INSERVICE INSPECTION

REV. 15	ISO. NO.: MCFI-2NI-15	DUKE PIPING CLASS: ASME SECT. III CLASS B	BUILDING: REACTOR
4	ADD CONT TO MCFI-2NI57 AND EL.	SYSTEM SYMBOL: SAFETY INJECTION	ZONE R-23
3	ADDED CLASS OF MATERIALS FOR GEN-STAR; ADD NOTE TO	PIPING SPEC.: NI-17 PS2501, NI-32 PS2501.2	
2	ADD MATS FOR CLAS A TO MAT & AT WELD NI2F475	DRAWING NO.: MC-244-D9.21-00,01	22-00,01
1	REL. FOR CDNST.	PROJECT: MC GUIRE	
0

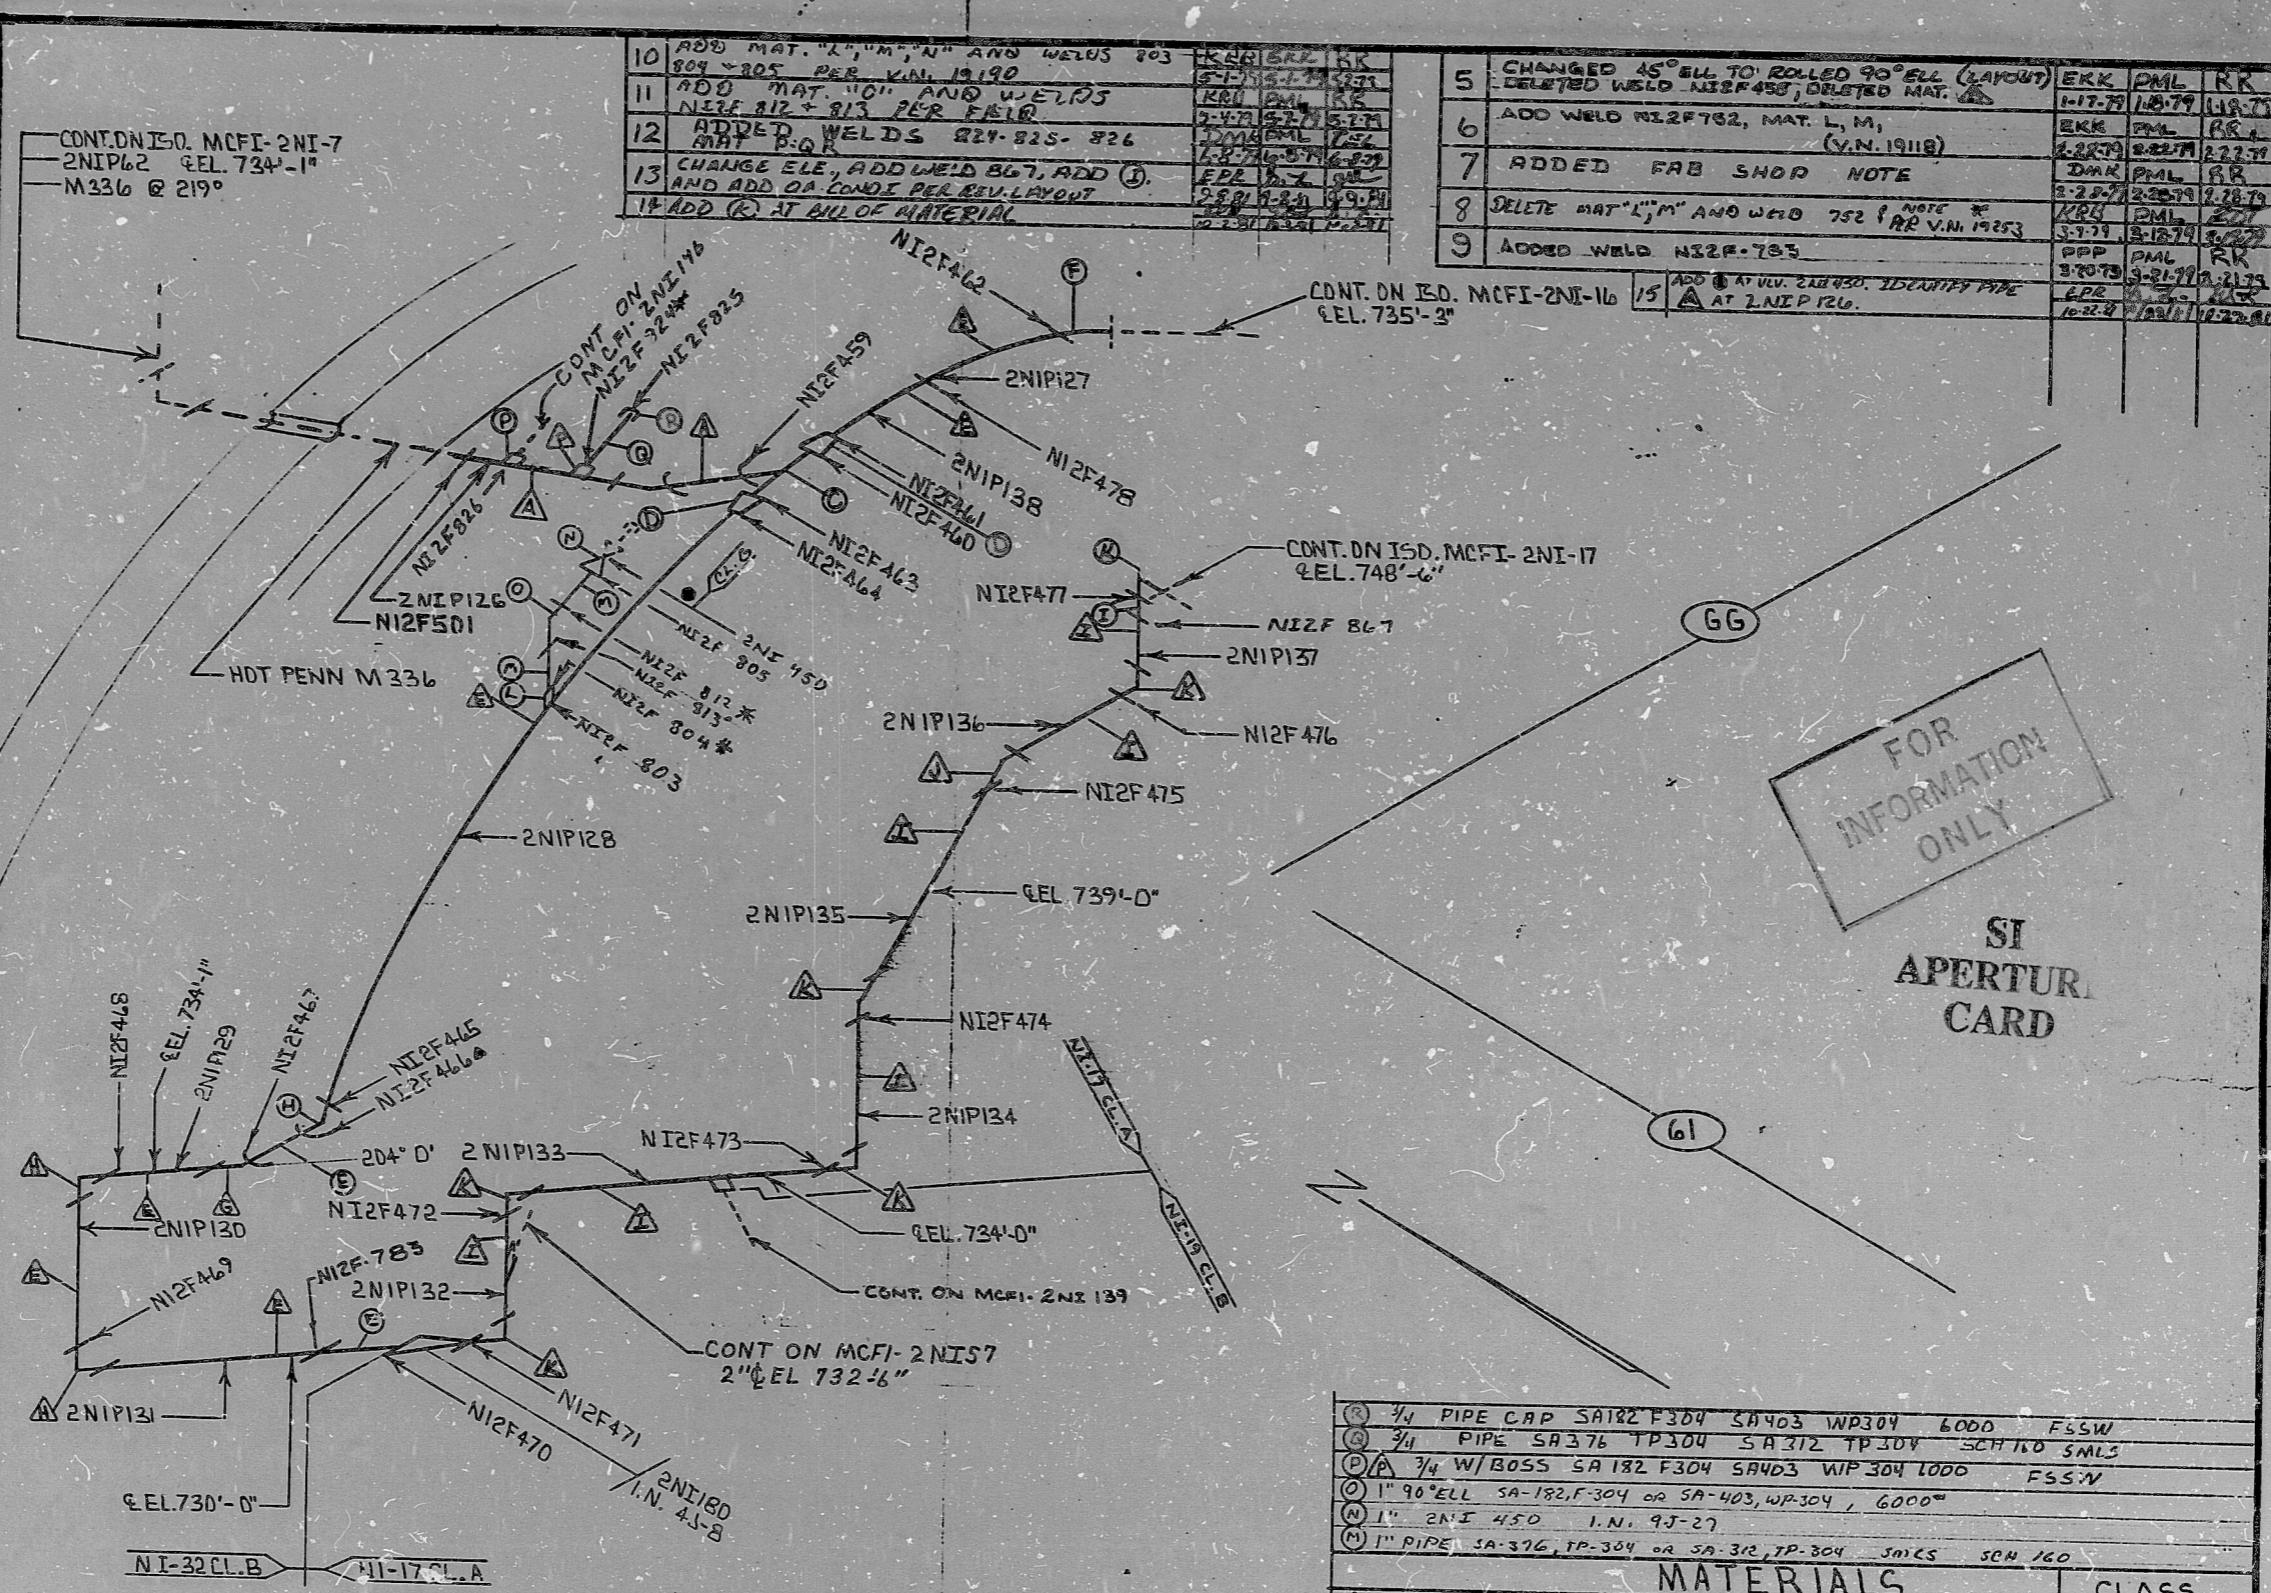
- 10 ADD MAT. "L", "M", "N" AND WELDS 203 804 - 805 PER V.N. 19190
- 11 ADD MAT "O" AND WELDS NI2F 812 & 813 PER F410
- 12 ADDED WELDS 821-825- 826 MAT. P-Q R
- 13 CHANGE ELE, ADD WELD 867, ADD (D) AND ADD ON CONDE REL REV. LAYOUT
- 14 ADD (R) AT ALL OF MATERIAL

| 5 | CHANGED AS ⁹⁰ ELL TO ROLLED 90 ⁹⁰ ELL (LAYOUT) | EKK | PML | RR |
| 6 | DELETED WELD NI2F458, DELETED MAT. (L, M, N) (V.N. 19118) | EKK | PML | RR |
| 7 | ADDED FAB SHOP NOTE | EKK | PML | RR |
| 8 | DELETE MAT "L", "M" AND WELD 752 (NOTE # 1) (V.N. 19153) | EKK | PML | RR |
| 9 | ADDED WELD NI2F-783 | EKK | PML | RR |
| 15 | ADD (R) AT VLV. 218 450. IDENTIFY PIPE AT 2NIPI 120. | EKK | PML | RR |
